NAIROBI RIVERS BASIN REHABILITATION AND RESTORATION PROGRAM: SEWERAGE IMPROVEMENT PROJECT PHASE II: LOT 4-CONSTRUCTION OF EAST AND WEST OF NAIROBI RETICULATION SEWERS ICB No: AWWDA/NaRSIP II/W-04/2021

#### REF: CLARIFICATIONS NO.2 TO THE ADVERTISED BID

### CLARIFICATIONS NO.2 TO THE ADVERTISED BID FOR PROCUREMENT OF WORKS FOR LOT 4-CONSTRUCTION OF EAST AND WEST OF NAIROBI RETICULATION SEWERSPROJECT. ICB No: AWWDA/NaRSIP II/W-04/2021

TYPICAL SEWER CONNECTION DETAILS

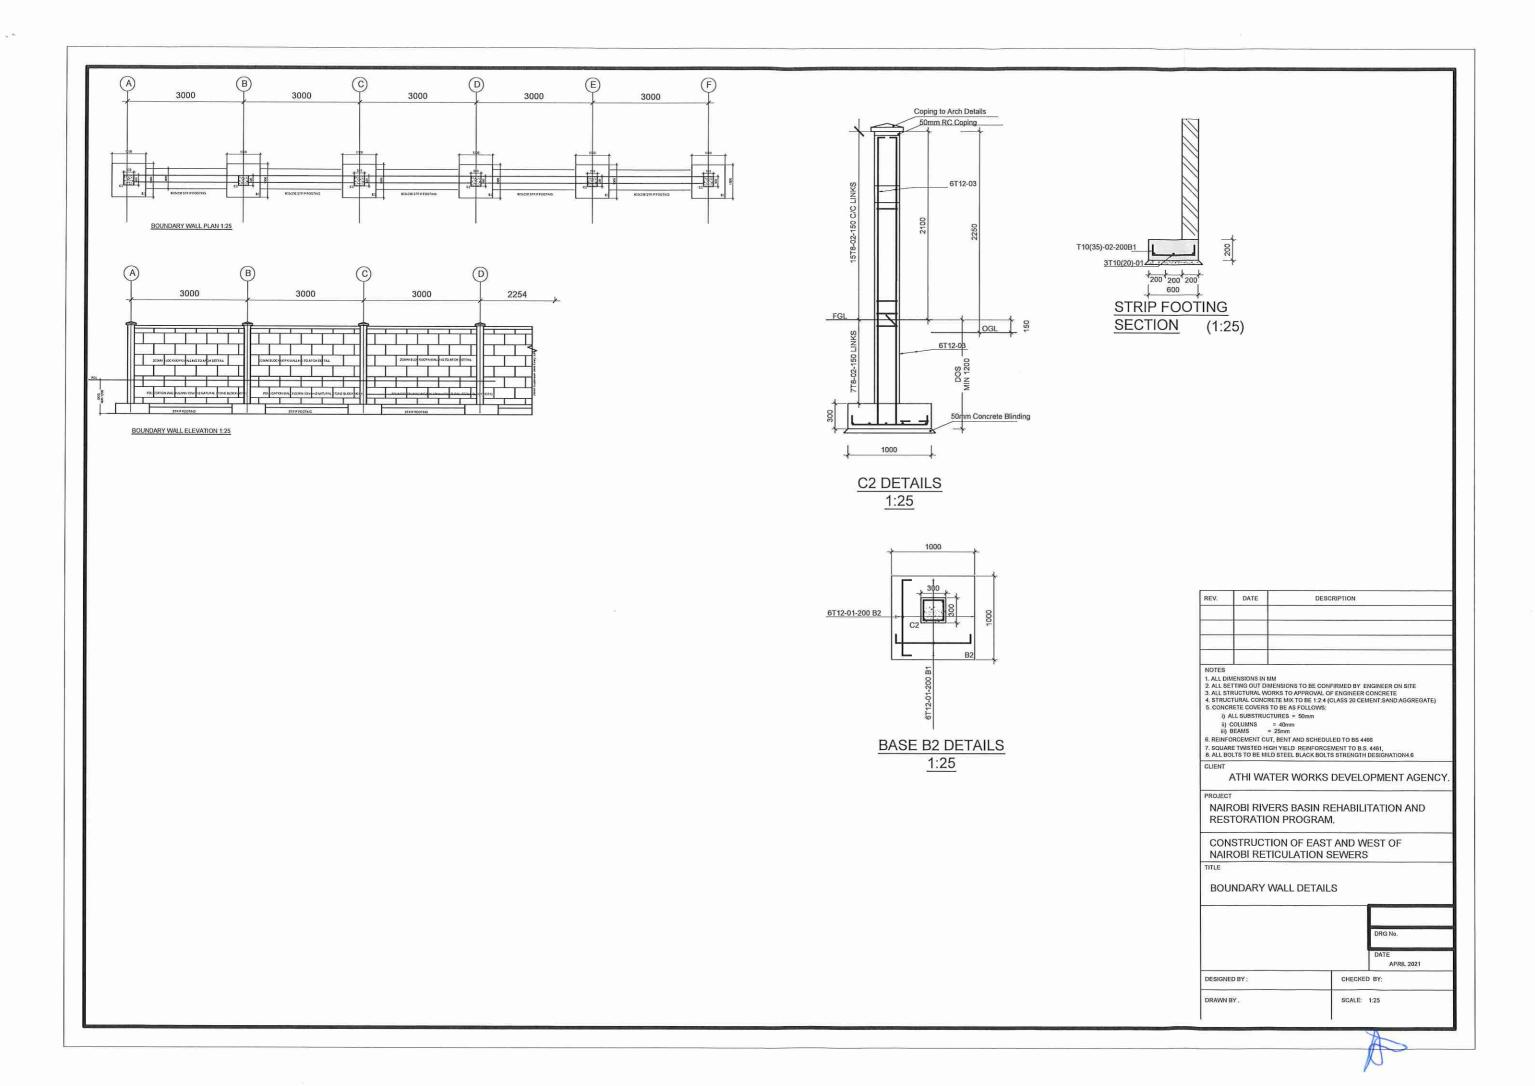
4.	There is no drawing/detail for Bill No. 13 HOUSEHOLD CONNECTIONS, please provide detail drawing to use for a Consumer Sewer Connection.	See annex 1 for the typical Household Connection drawing.

# BOUNDARY WALL/MASONRY FENCE DRAWING

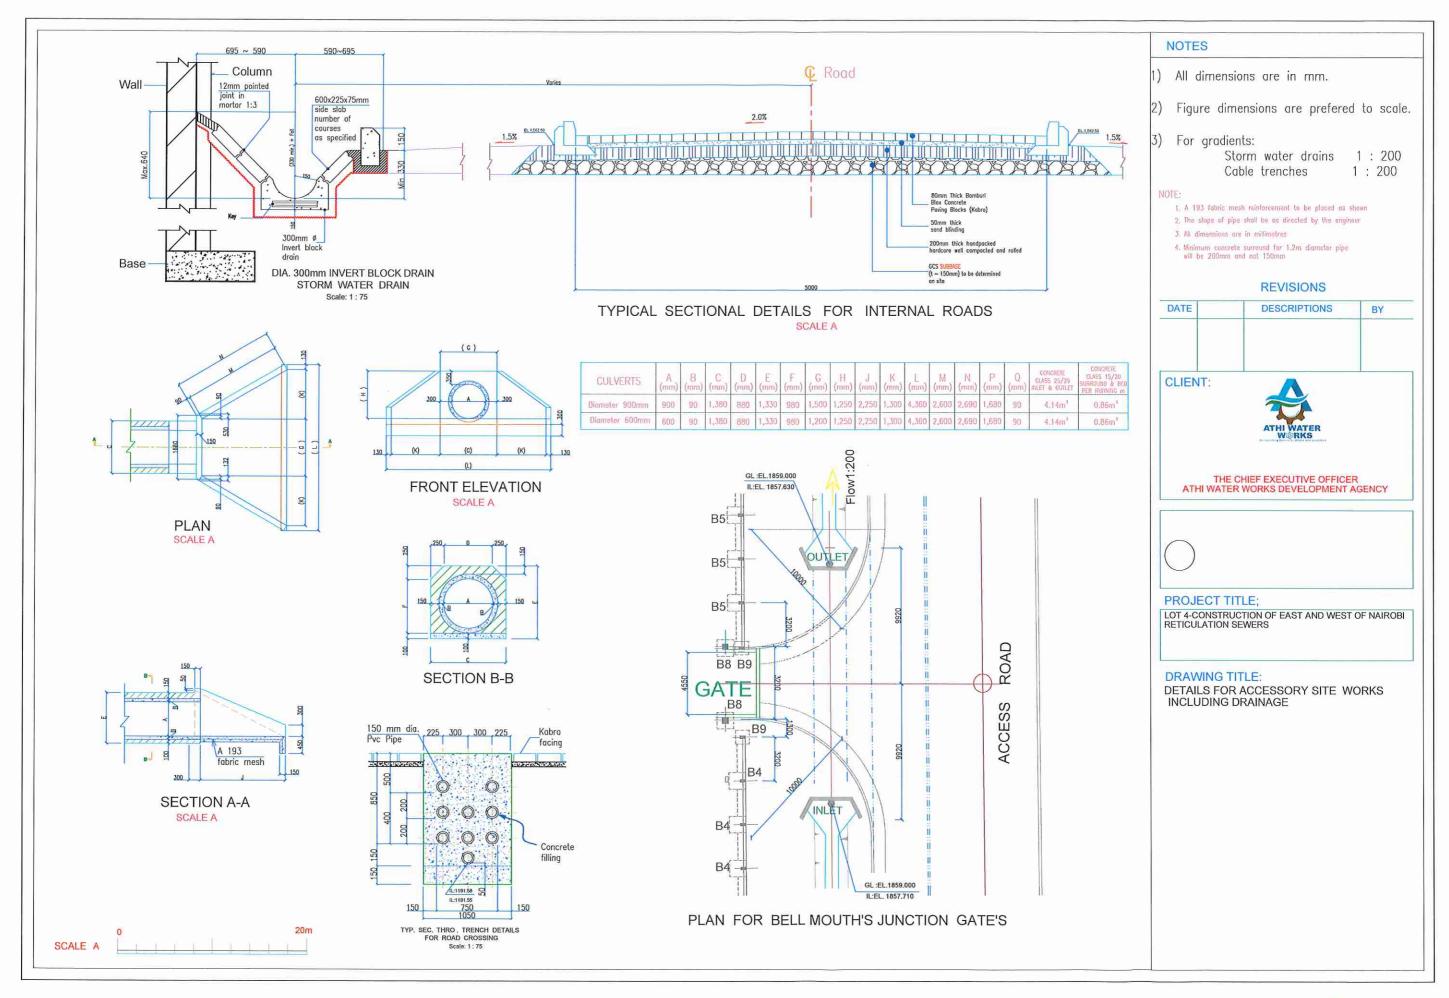
5.	There are no drawing/ detail for Bill NO.15 KAREN PONDS FENCING X.2 Masonry fencing, X.4 Security gate, please provide detail drawings	See annex 2 for the masonry fence drawing
